Approval no: DEV2023/1369

PRECINCT TWO - VILLAGE 4A (APPLICATION NINE) RECONFIGURATION OF A LOT

AMENDED IN RED

PRECINCT TWO - VILLAGE 4A (APPLICATION NINE) RECONFIGURATION OF A LOT PLAN OF DEVELOPMENT

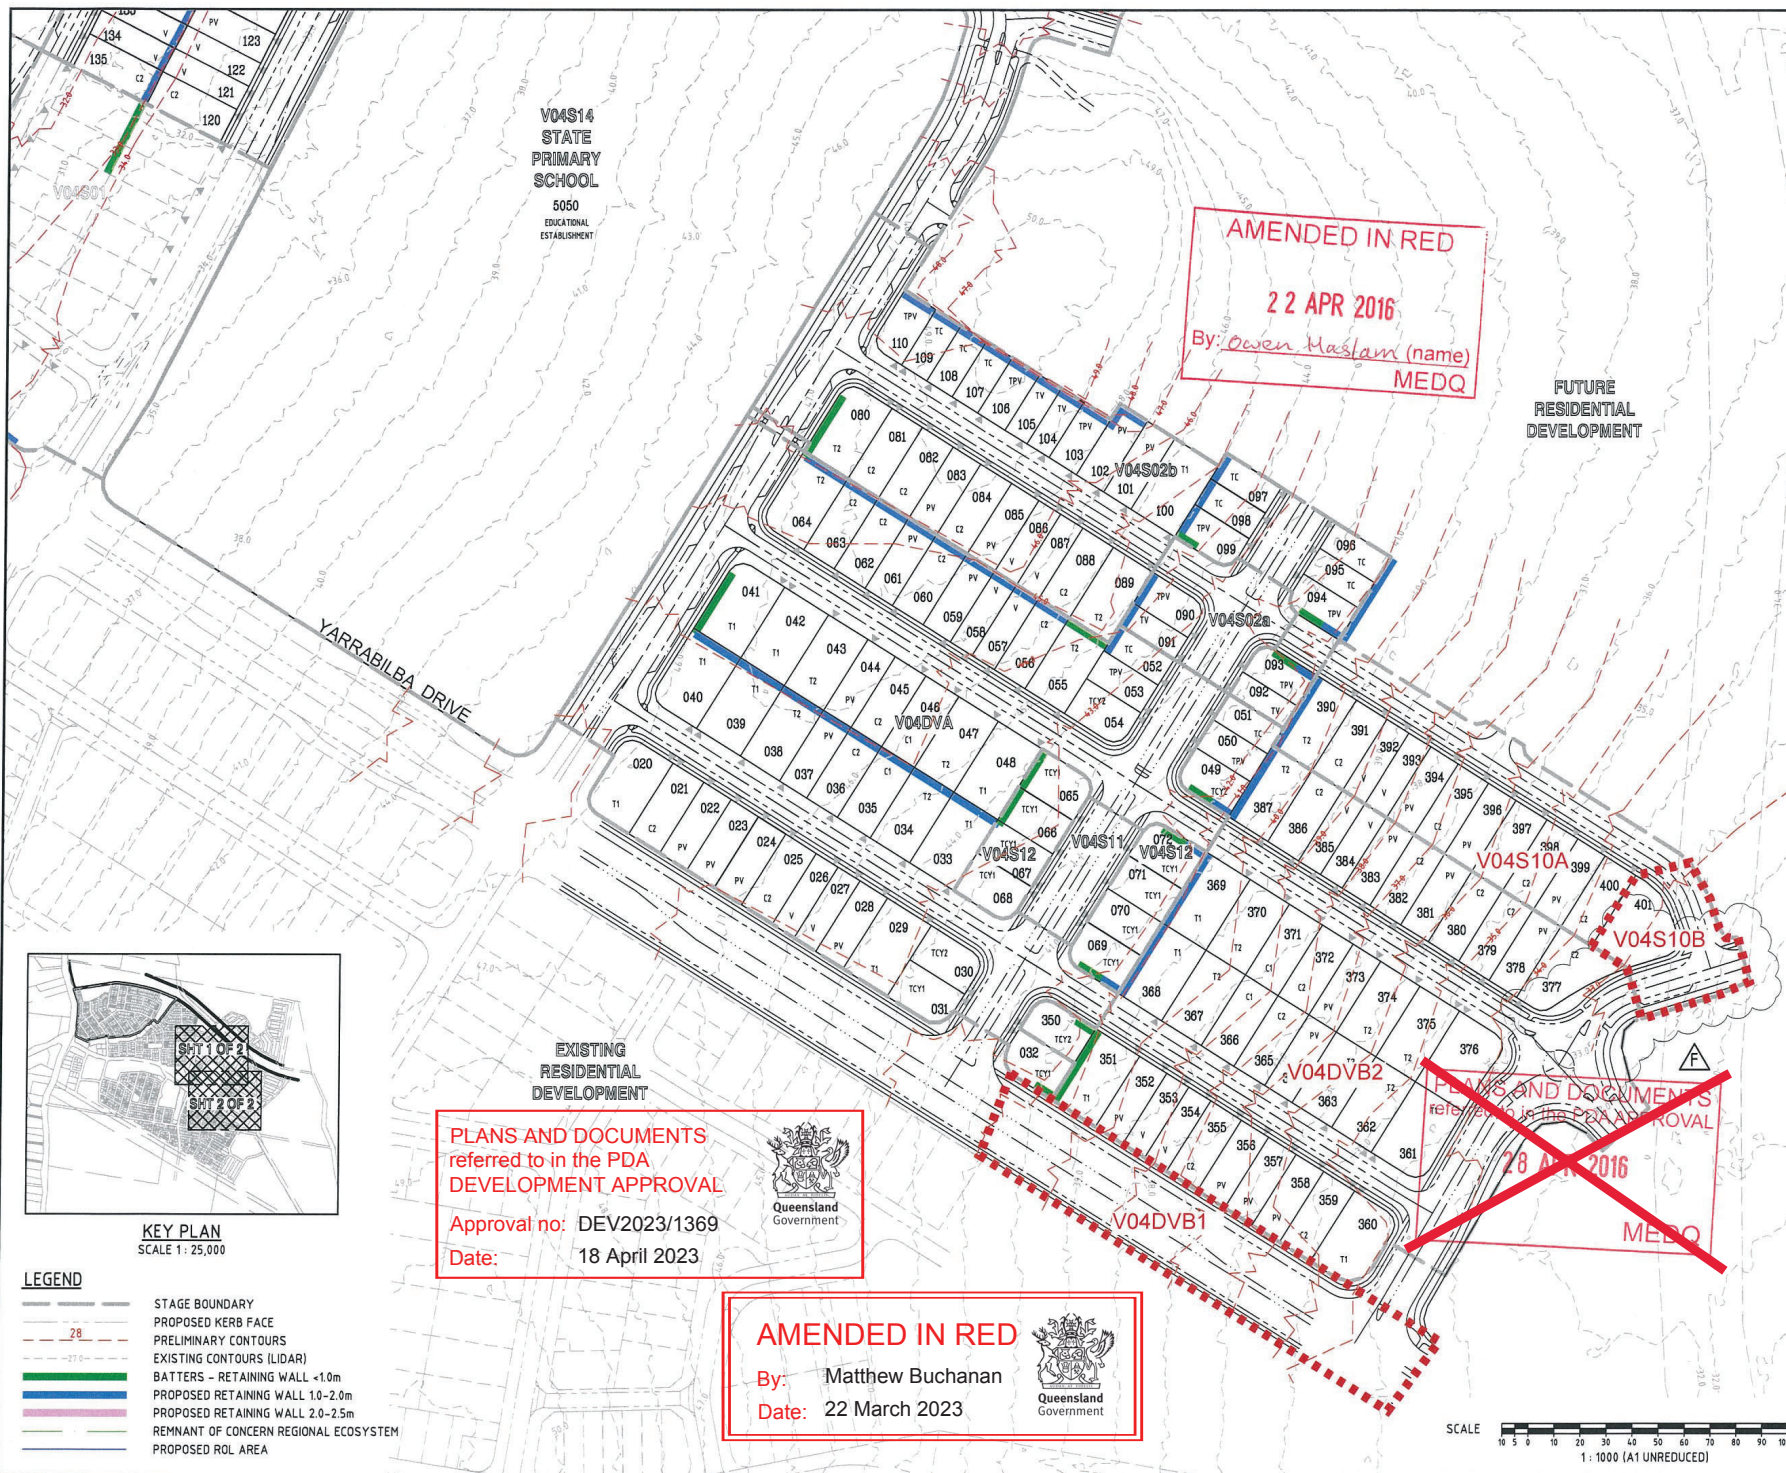
- ~~Acoustic treatment may be required for some lots, refer to report prepared by MWA Environmental.~~
 - Construction standards/setbacks may be affected by bushfire risk. Refer to the Sub-Precinct Specific Bushfire Hazard Assessment and Mitigation Plan for Sub-Precinct 4E Yarrabilba, prepared by Bushfire Protection Systems Pty Ltd.

- ~~For garages on front loaded lots less than 10m in width the following criteria must be met:~~
- ~~Single storey homes must have a single or tandem garage.~~

- ~~Double storey homes can have a double garage provided the 2nd floor front wall or balcony is a minimum of 500mm forward of the garage wall.~~
- 5. Driveways:**

- 13. Houses on Narrow Residential Lots (10m-12.49m in width):**
- ~~Houses on Lots 10m-12.49m in width must adhere to the following design criteria:~~
- ~~The front facing building wall, which comprises the garage door must not exceed an external width of 5.7m.~~
 - ~~The garage door:

- Width must not exceed 4.8m;
 - Must have a minimum 450mm eave above it;
 - Must be setback a minimum of 240mm behind the garage door; and
 - Must have a sectional, tilt or a roller door.~~
 - ~~The front facade of the dwelling must be forward of the alignment of the garage wall and must include the following:

- A front entrance door and windows and a side light;
 - A front verandah, portico or porch located over the front entrance, which extends a minimum of 1600mm forward of the entrance door;
 - The verandah, portico or porch is to include front piers with distinct materials and / or colours.~~
- 14. Residential Lots with Park Frontage:**
- ~~Fencing along park frontages must be:

- 1.2m high solid; or
 - Up to 1.8m high if containing openings that make it more than 50% transparent.~~
 - ~~Dwellings are designed to include habitable rooms that face the park.~~

- 16. Criteria for Variations to an approved plan assessed via compliance assessment:**
- Applications for compliance assessment to vary the layout must be in accordance with the criteria outlined below. Changes that are not in accordance with these criteria will require lodgement of a change application, pursuant to Section 99 of the Economic Development Act 2012.
- ~~Minor variation to the boundaries of parks subject to achieving the following:

- The size of the park does not vary by +/- 5%;
 - The boundary of a park does not vary by more than 10m in any direction; and
 - No change to the location and classification of the proposed park are made; and
 - Minimum park size and embellishments under Community Greenspace IMP and EDQ Park Planning and Design Guideline 12 and met; and if it is required to accommodate a pad mount transformer with a maximum area of 5m x 5m.~~
 - ~~Minor variations to the road network subject to achieving the following:

- The classification of the road is not varied;
 - The location of a road is moved by not more than 10m in any direction;
 - Any change to a road location does not result in a new intersection within 50m of another intersection; and
 - The change of the road does not result in a block length of more than 200m; and
 - Retains grid or modified grid responsive to site characteristics; and
 - Does not result in an additional cut-de-sac; and
 - Demonstrate the variation accords with provisions within Guidelines 5, 6 and 13.~~
 - ~~Variation to lots subject to achieving the following:

- The total number of lots is within +/- 5% of the number of lots already approved; and
 - The footprint of the lots is within the existing residential lot footprint (with the exception being where a road is moved in accordance with the provisions in Item b(i) above); and
 - It can be demonstrated where a lot increase is proposed that adequate on-street parking exists for visitors to the lots; and
 - Where a paramount transformer is required max 5m x 5m.~~
 - ~~Variation to the approved POD where:

- To amend setbacks as a result of a lot change; or
 - To change the location of a built to boundary wall or driveway;
 - It is noted a compliance assessment process cannot be used once any lot in the stage subject to the change has been sold.~~
 - ~~Variations to staging or creation of sub-stages:

- Permitted when not resulting in a park being created in a stand-alone stage or where a park is in the final stage with less than 10 residential lots associated with it.~~
- Where a variation is proposed, the applicant must submit to EDQ for compliance assessment:**
- ~~A statement demonstrating compliance with the criteria above and relevant section of PDA Guidelines and Practice Notes.~~
 - ~~Where minor variations are required due to detailed engineering design a statement outlining the~~
 - ~~Reason for the variation and how the variation responds to Guidelines 13 Engineering Standards.~~
 - ~~Updated ROL and POD plans as applicable.~~
 - ~~Updated Functional Layout Plans (if applicable).~~
